MEMORANDUM

TO: District of Columbia Board of Zoning Adjustment
FROM: Karen Thomas, Case Manager
Joel Lawson, Associate Director Development Review
DATE: April 24, 2012
SUBJECT: **BZA Case 18345** - Request pursuant to DCMR 11 § 3104 for special exception relief per § 223 to construct a garage at 2933 Tilden Street N.W.

CASE NO. 18345

East Elevation (Sheet A-4)

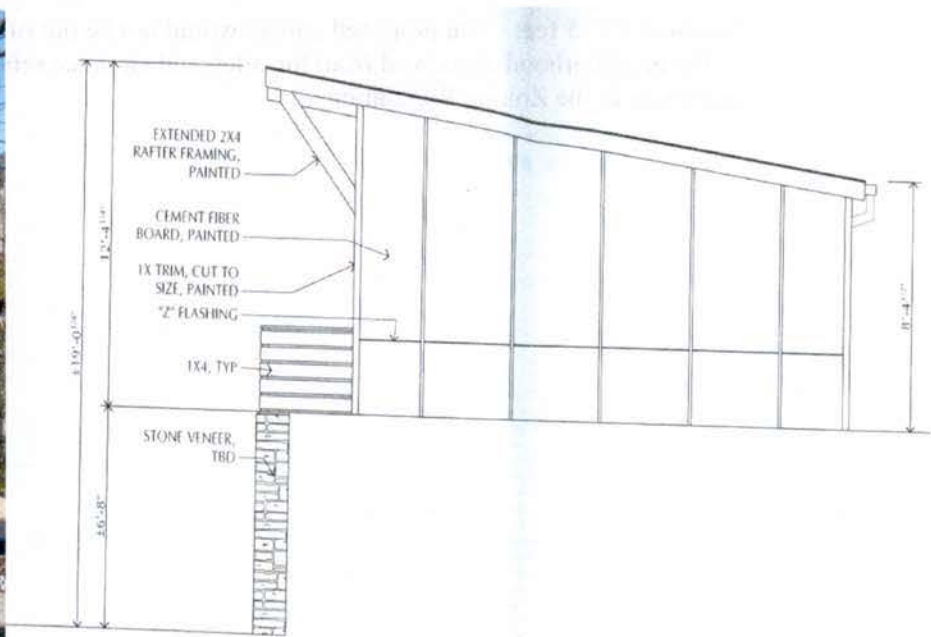
The property exhibits an exceptional condition, due to the location of the existing parking pad at 6.75 feet above the finished grade of the rear yard, as can be seen on Sheet A-4 of the submitted plans and photograph. This grade difference creates a practical difficulty for the applicant in meeting the 15-foot height requirement as measured from the finished grade at the middle of the south elevation, to the highest point of the roof of the building (§ 2500.7). A proposed design to satisfy this requirement would adversely impact the height of the garage's entrance from the alley making it impractical for use as a garage. Reversing the slope to accommodate the 15 foot height as measured from the rear yard, would increase the garage's height as viewed from the alley and it would not appear in character with other garage structures as viewed from the alley. Similarly, a flat roof design would not adequately accommodate the structural requirements of the interior and leave efficient space for parking the vehicles.
